SUBJECT: Describes changes planned for fire protection safety
 evaluation sections re commitment to provide capability to
 cool RHR pump seal coolers via emergency svc water sys.
 Forwards drawing of interconnection schematic.

MONTICELLO NUCLEAR GENERATING PLANT
Docket No. 50-263 License No. DPR-22

Redundant Cooling of RHR Pump Seal Coolers Required
by Fire Protection Safety Evaluation

ESW - RBCCW INTERCONNECTION*

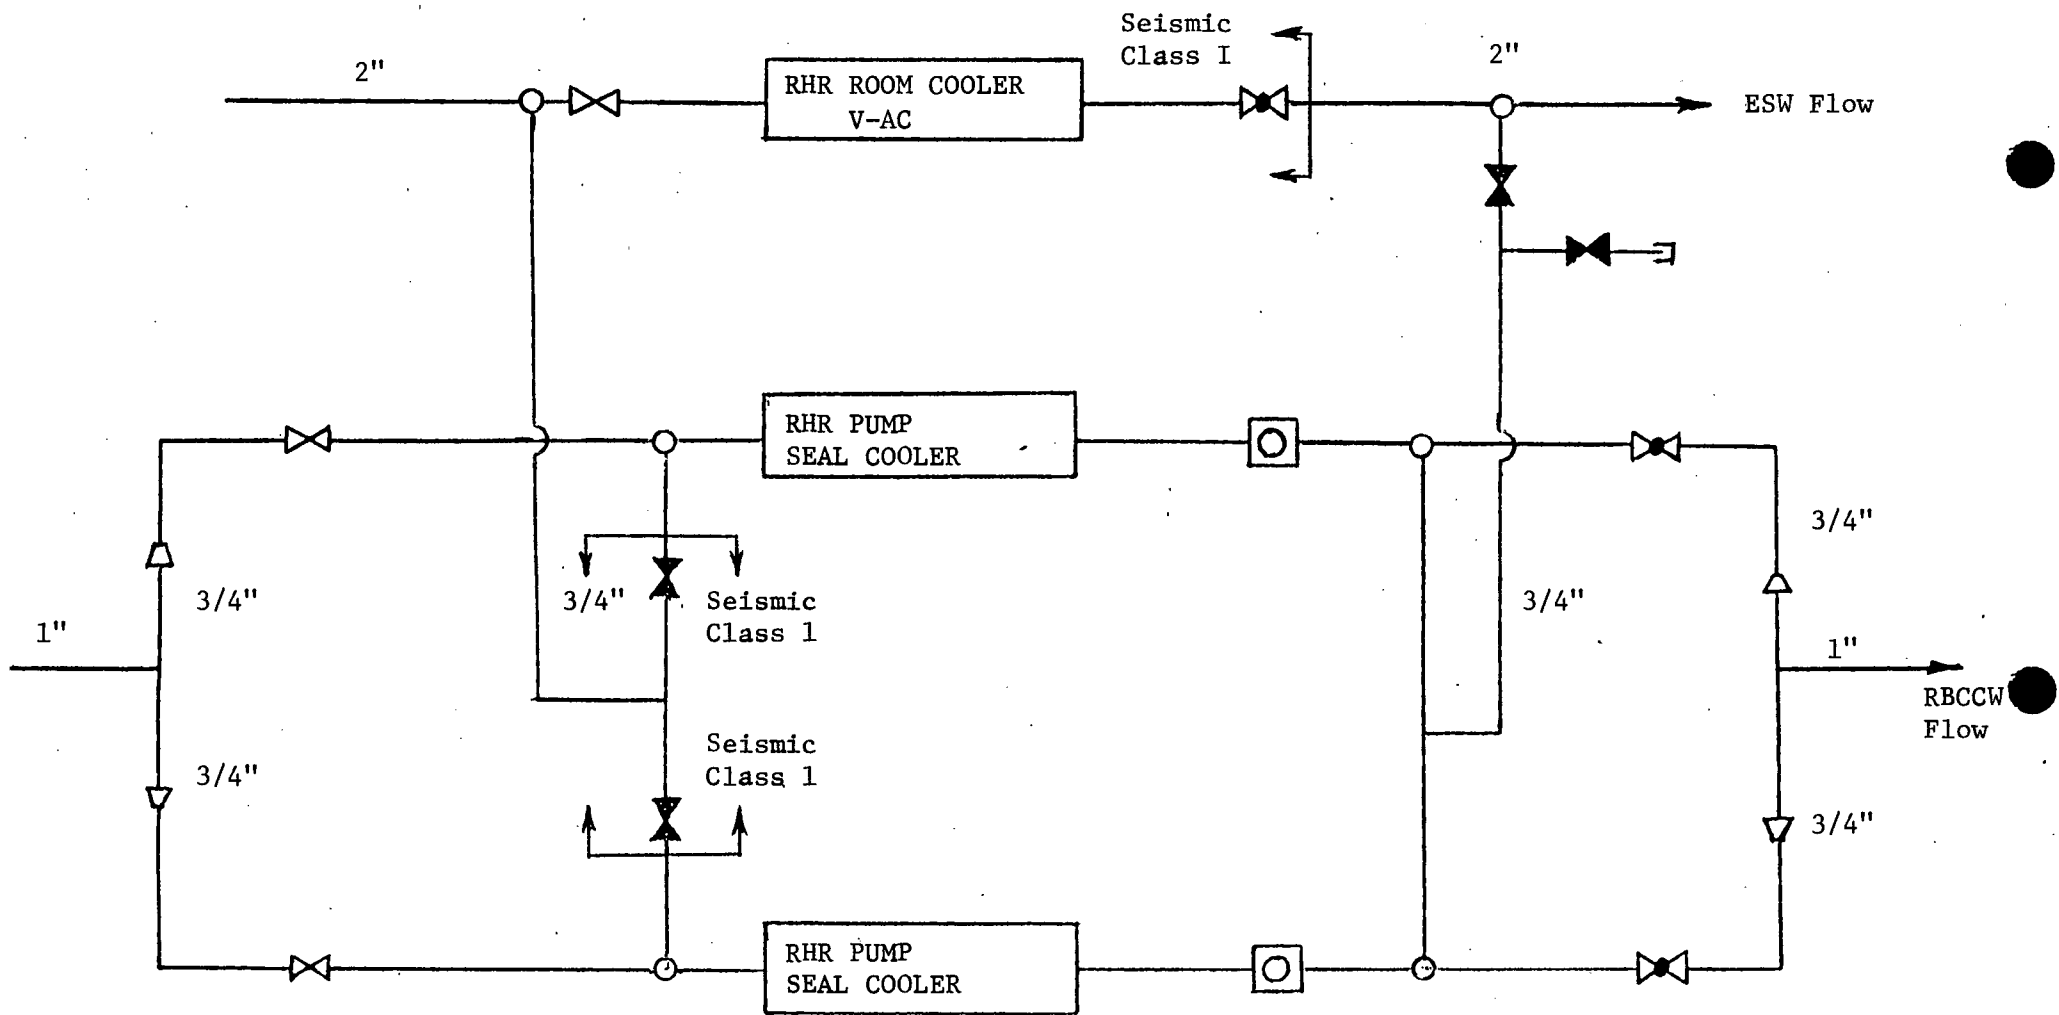
Cooling of RHR pump seal water is required only when these pumps operate with pumped fluid temperatures greater than 165°F. This condition is only expected to occur if a pump is operating in its shutdown cooling mode. In the event of a fire which would necessitate plant shutdown, reactor cold shutdown must be able to be achieved and maintained within 72 hours. If the fire disabled the RBCCW system, cold shutdown could be achieved by using the ESW system to provide cooling to the seal cooler for the single RHR pump required for shutdown cooling.

The attached sketch shows a schematic of the interconnection as planned. The emergency service water system is seismic class 1 up to the first valve after the RHR room coolers. The interconnection will be classified and supported as seismic class 1 up to the interconnection isolation valves. The additional load on the ESW pumps for this modification is expected to be less than 2%, 8-10 gpm. This is within capabilities of the existing ESW system.
